ATTACHMENT A
RESPONSE TO COMMISSION'S REQUEST FOR ADDITIONAL INFORMATION (23-11-18)

Figure 2: Growee River sub-catchment within Bylong River

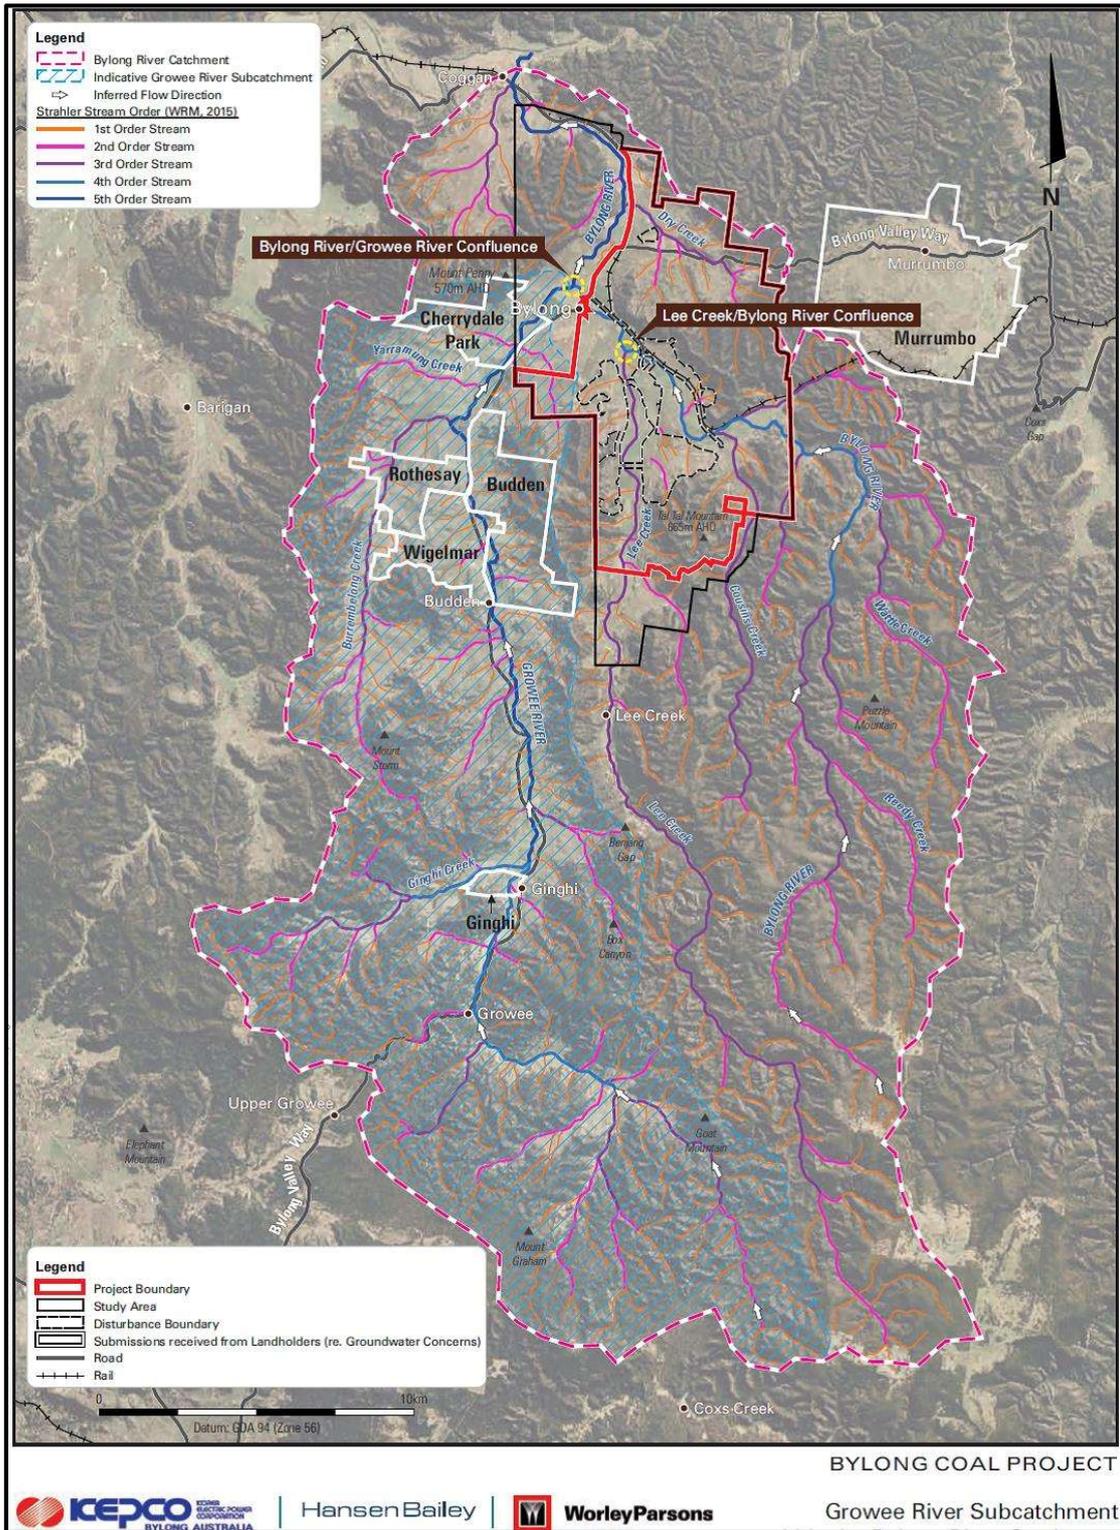
KEPCO has acquired all agricultural properties in the Upper Bylong and the Lee Creek catchments, with remaining private landowners located predominantly in the adjoining Growee River catchment which flows into the Bylong River downstream of Bylong village (see Figures 1 and 2 below).

Figure 3: Likelihood of drawdown exceeding 2m in the alluvial aquifer

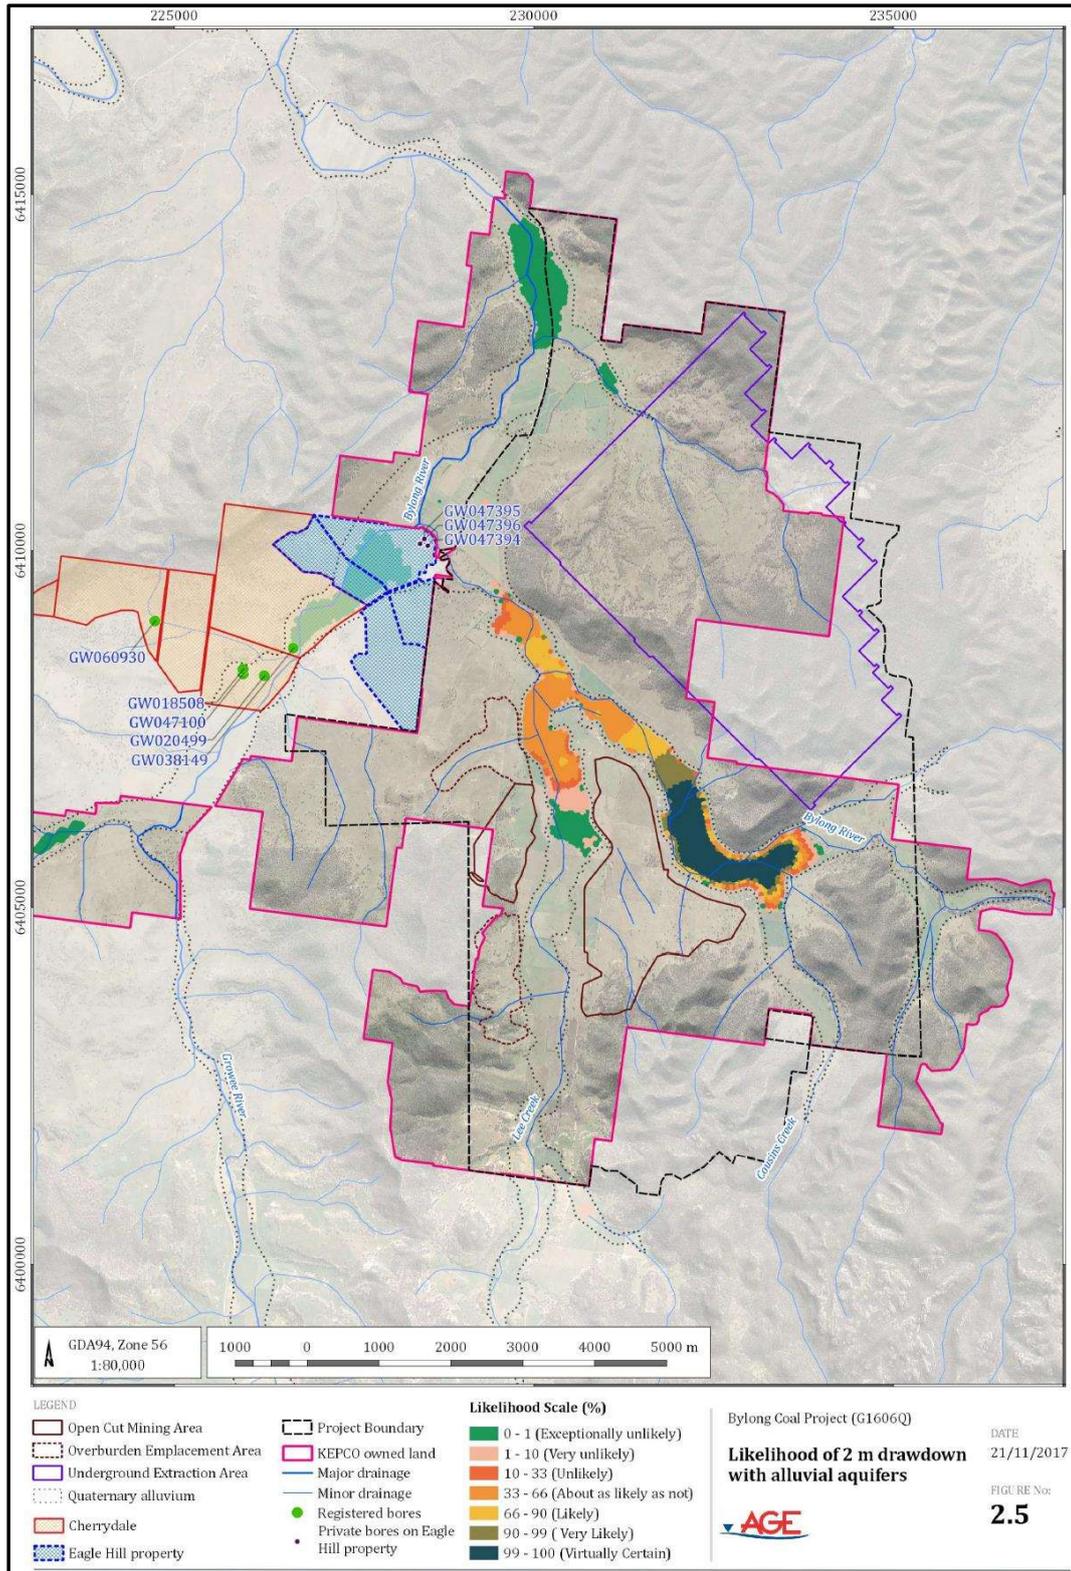
The potential for significant impacts to groundwater availability to neighbouring properties, specifically what is the probability that the project will have an adverse impact on the availability of groundwater to neighbouring properties and what the “worst-case” scenario would be, taking into account climate change factors?

The groundwater modelling drawdown results are consistent with this model conceptualisation with the worst case predicted drawdown largely confined to the upper Bylong Valley with little drawdown predicted within the Growee River valley, as shown in Figure 3 below, with drawdown exceeding 2m predicted to be exceptionally unlikely to occur within the Growee River alluvium (1%ile likelihood based on uncertainty analysis from 140 model runs), near the confluence of the Growee and Bylong rivers.

This is due to the potential for depressurisation of the coal seam which sub-crops under the alluvium – however, this is the prediction from only 1 model run out of 140 due to adopting highly permeable hydraulic properties in the uncertainty analysis, considered unlikely by AGE based on field measurements.

The prediction also includes borefield pumping for mine water supply and agricultural and induced take from depressurisation of mining in the coal seams. The majority of uncertainty modelling runs (from 1-10%ile very unlikely to occur to >99%ile virtually certain to occur) confine predicted drawdown impacts exceeding 2m to the Upper Bylong Valley.

Figure 4: Drawdown in alluvial aquifer due to induced take from mining the Permian coal seam

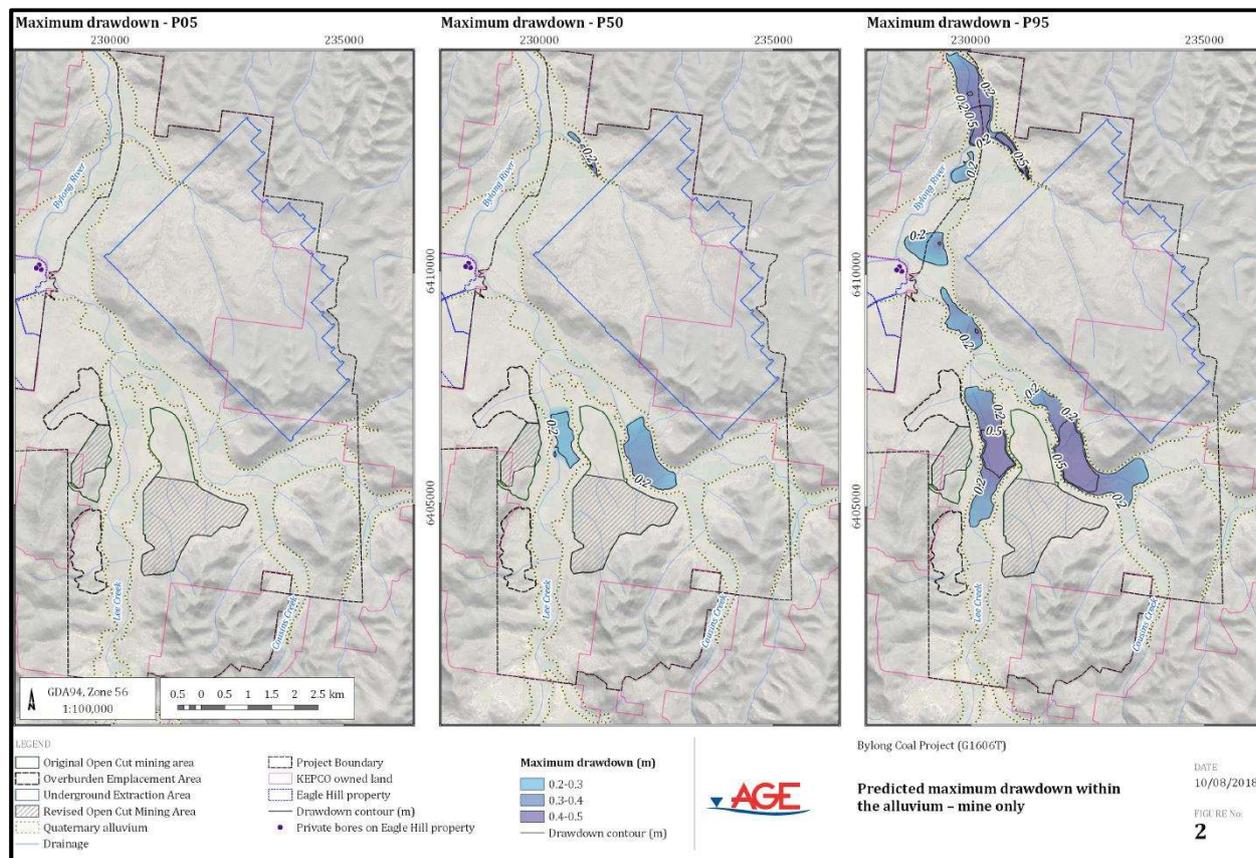
The predicted drawdown in the Bylong alluvium due to the project is mainly from the take of alluvial water from the proposed mine bore-field, with only a small component (up to 0.5 m based on uncertainty analysis range 5%ile to 95%ile results) of drawdown predicted to be from induced take from the depressurisation of the targeted coal seams (see Figure 4).

Figure 5: Variation to Specific Storage (Ss) compared to basecase model run

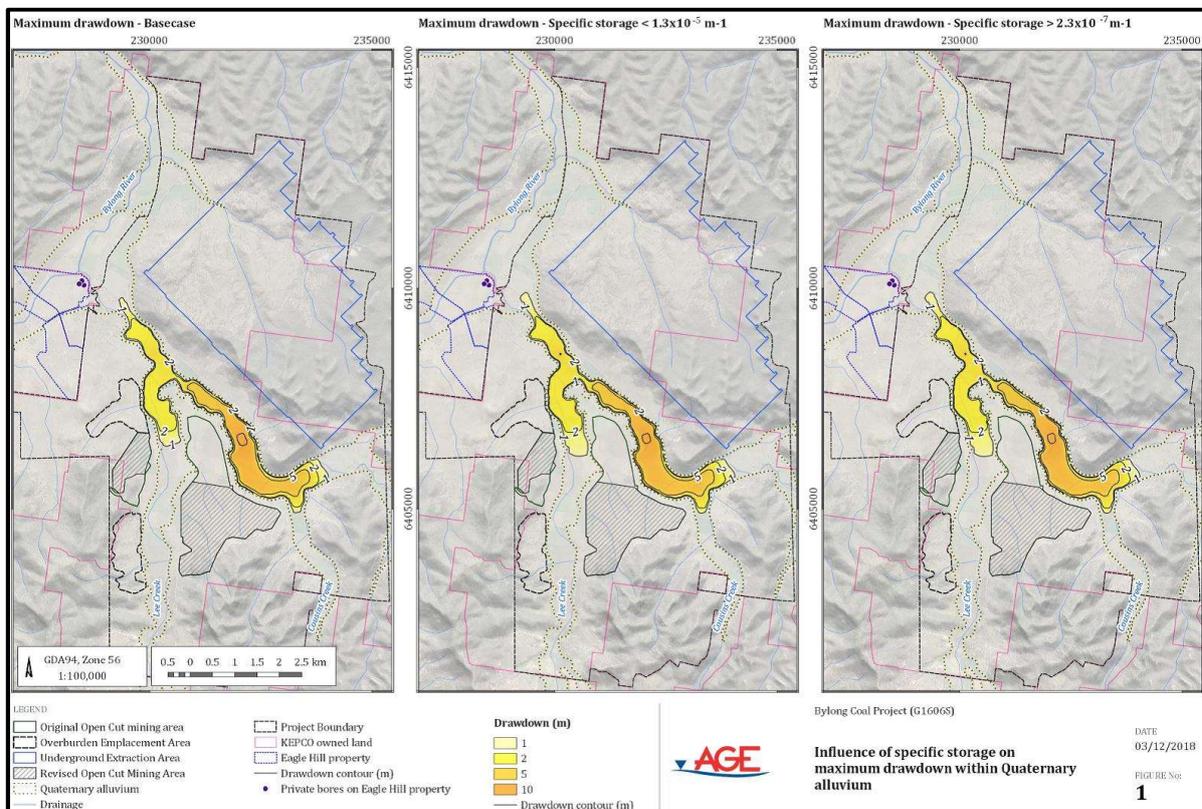
The Department notes that the Anderson/BVPA submission to the Commission raised some technical concerns with the groundwater modelling, particularly related to assumptions about the hydraulic parameter of specific storage (Ss), a hydraulic parameter related to confined aquifers, based on recent research papers. KEPCO's groundwater expert has provided a response to these concerns (see Attachment B) with the key points being:

- AGE undertook additional sensitivity analysis of impacts on alluvial drawdown using the Ss range suggested, with little change in predicted impacts on drawdown on the alluvial aquifer compared to the base case model run. This is largely due to the Ss changes not affecting the unconfined aquifers in the model and the increased depressurisation in the Permian confined layers does not lead to any significant increase in induced impacts on the overlying unconfined alluvial aquifer (see Figure 5 below).

Figure 6: Water Storage Inventory over the project life – Revised Mine Plan

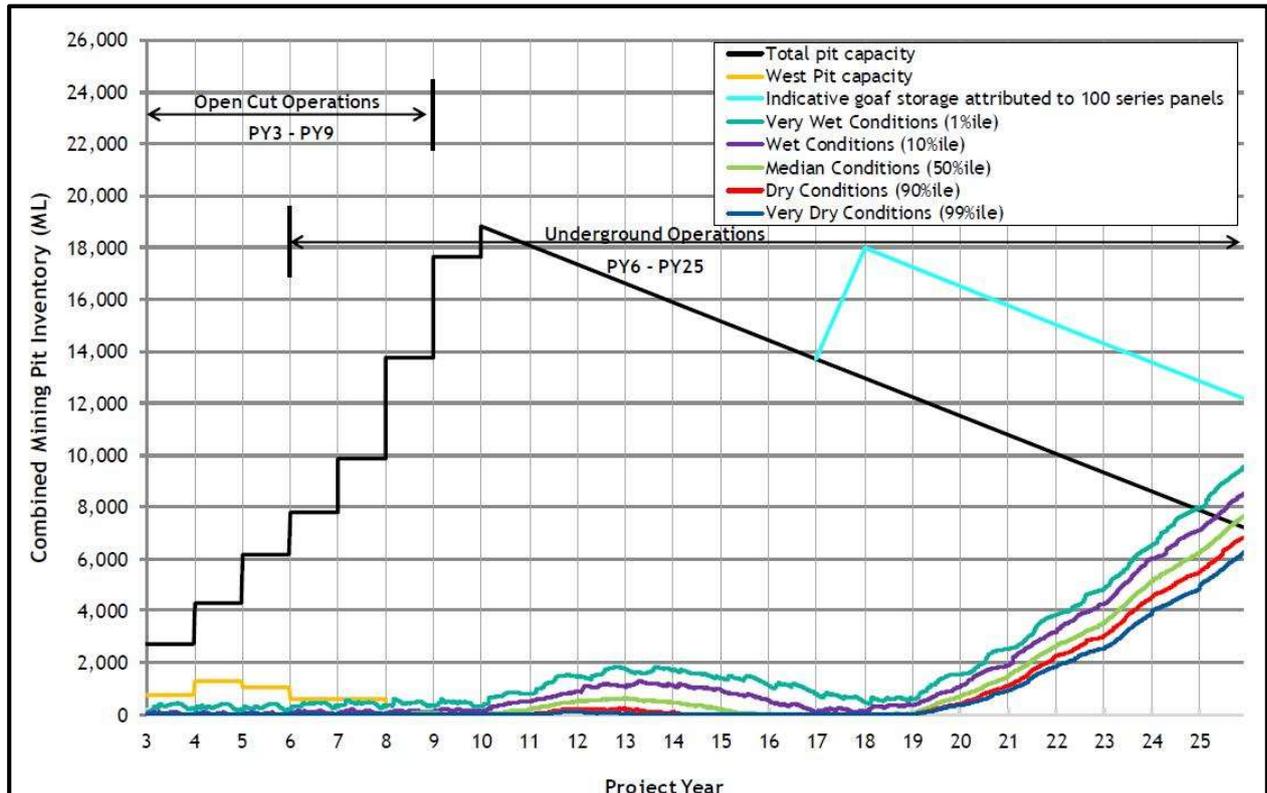
Clarification on the potential safety risks of water storage in the mine underground goaf, and the relationship and importance of this water storage option on the overall function of the Project's site water balance.

As outlined in the Final Assessment Report, KEPCO undertook additional water balance runs including sensitivity analysis to demonstrate that it could manage excess water without discharge to surface waters under a range of conditions. Figure 6 below shows the likely scenarios for site water inventory against available water storage – incorporating very dry (99%ile) to very wet (1%ile) rainfall conditions for the Revised Mine Plan.

The modelling shows that there would be sufficient storage in the open cut void for most of the project life. Under very wet conditions the goaf storage would be required by year 25 of the project life.

The sensitivity analysis showed that, under worst case model scenarios, this would bring forward the use of the goaf storage to around year 23, with sufficient goaf storage capacity to manage excess water. Only in one (very unlikely) scenario modelled (high groundwater inflow combined with very wet 1%ile rainfall sequence over the life of the mine) would the series 101 goaf storage be insufficient.
